PLANNING REPORT - Major Site and Building Plan Review and Conditional Use Permit

RE: Sunfish Lake – 357 Salem Church Road– Site and Building Plan Review and Conditional Use Permit

Re: Major Site and Building Plan Review, Submittal 02/18/19
357 Salem Church Rd
City of Sunfish Lake, MN
WSB Project No. 013527-000

Figure 2
PROPOSED CONDITIONS MAP
357 SALEM RD RENOVATION
City of Sunfish Lake | Dakota County, MN

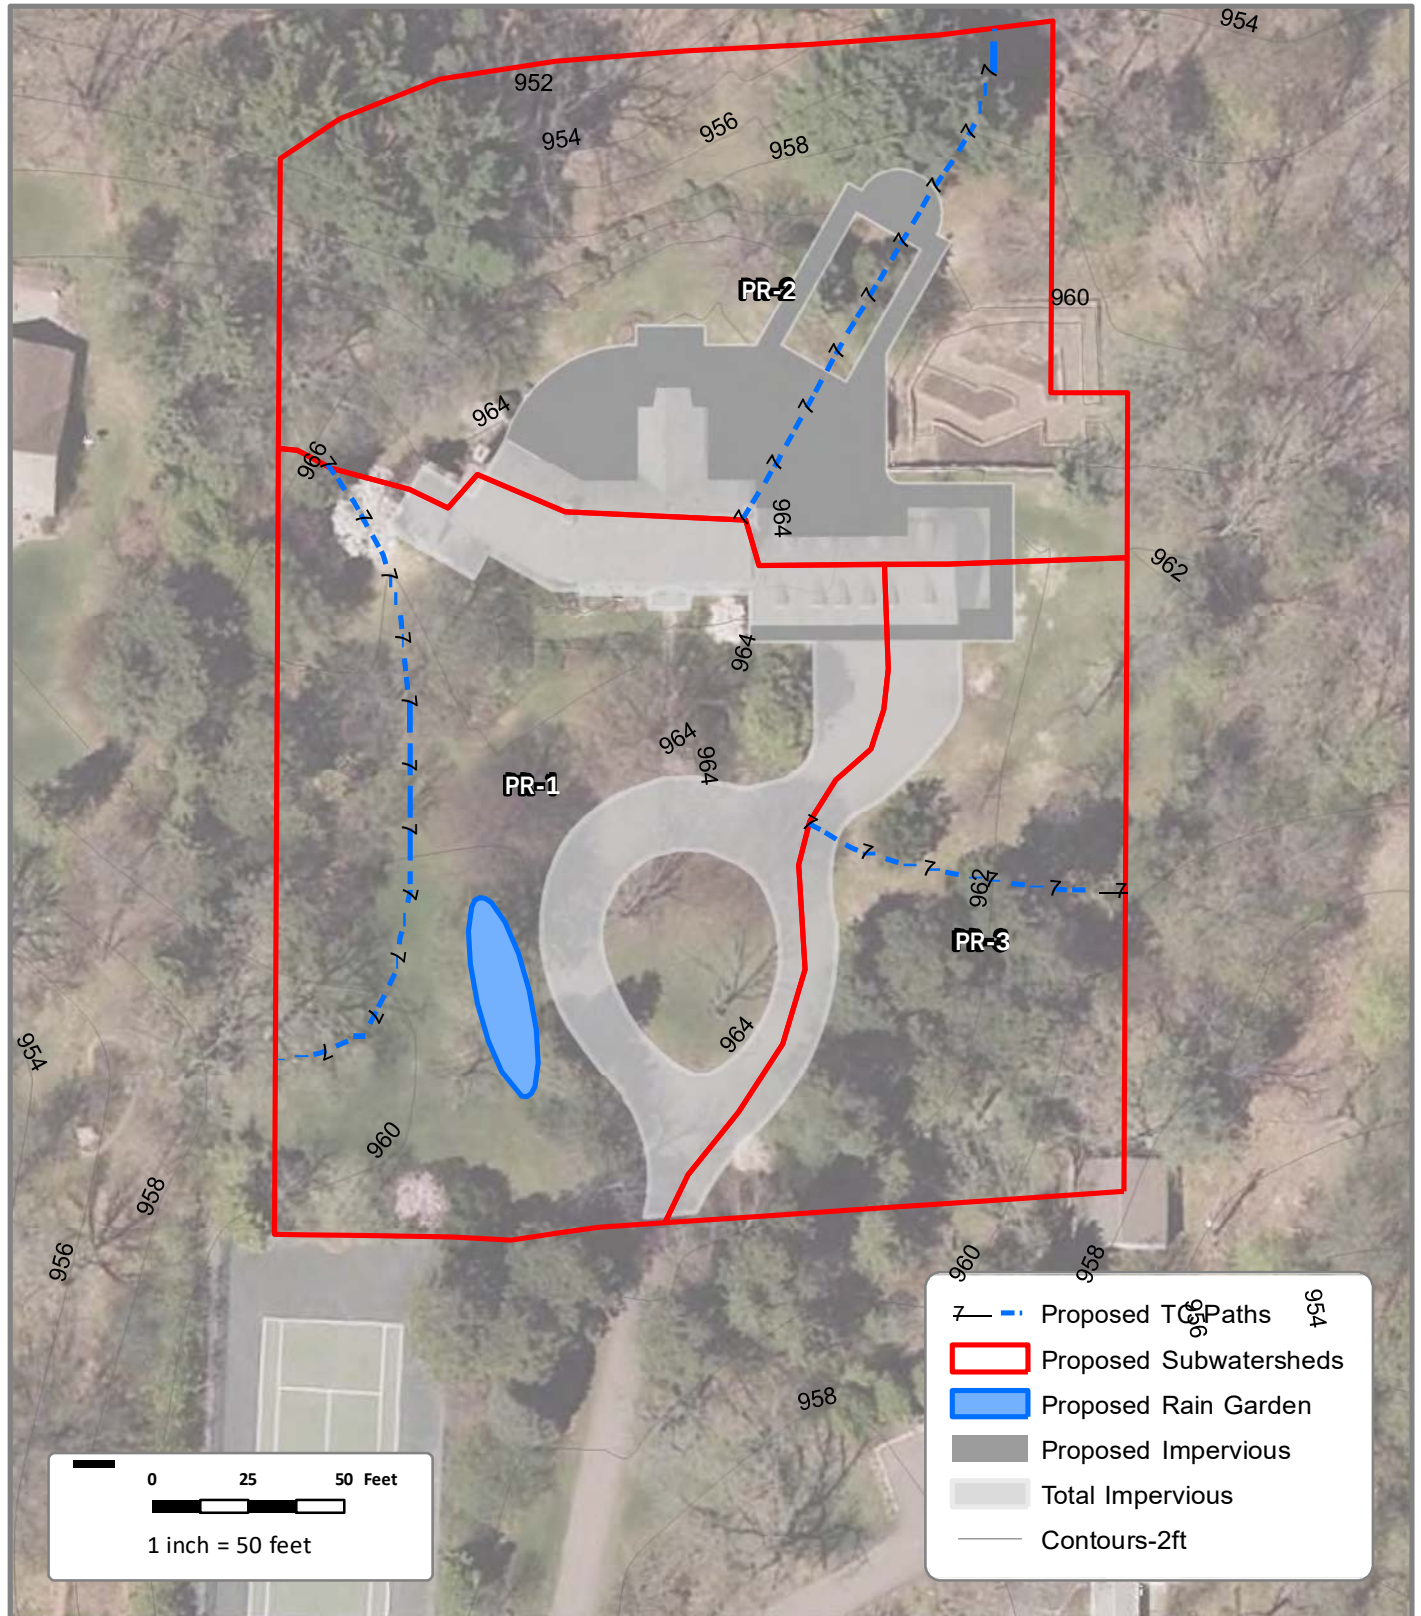
1. The majority of the new impervious is being added onto the back of the building and is proposed to be discharged directly into Sunfish Lake without treatment. The applicant should route the new impervious to a stormwater BMP prior to discharging into Sunfish Lake to provide the required water quality treatment.

2. Proposed changes to the property do not appear to alter the overall existing drainage patterns. The existing drainage area map should be split into the three drainage areas, similar to what is shown in the proposed conditions drainage area map.

3. From the grading shown in the plans, it appears that the southwest corner of PR-1 will not drain to the proposed rain garden. The PR-1 drainage area should be split to accurately depict the proposed drainage.

4. The Minnesota Stormwater Manual recommends a minimum slope for filtration basin underdrains of 0.5%. Applicant should be update the proposed underdrain to meet this recommendation.

5. The Minnesota Stormwater Manual recommends for filtration basins to have 18" of filter material above the top of the underdrain. The proposed underdrain inverts indicate that only 8" of filter material would sit above the underdrain.

6. The rain garden EOF location and elevations should be added to the plans.
7. The invert elevations for the draitile shown on the plans are inconsistent with what is being modeled in HydroCAD. Applicant should update the model to represent what is shown in the plans.

8. Applicant should update the note within the rain garden detail to state that the exfiltration rate of the filtration basin will be tested at the end of construction to ensure rates are meeting or exceeding the design rate. If the design rate is not being met, the media will be amended until the design rate can be met.

9. The narrative in the stormwater management plan lists a design infiltration rate of 1.6 inches per hour while the HydroCAD model is only using a rate of 1.2 inches per hour. Applicant should update either the HydroCAD model or the narrative to the appropriate rate.

1. All comments in this section from the review memo dated 02/28/19 have been addressed.
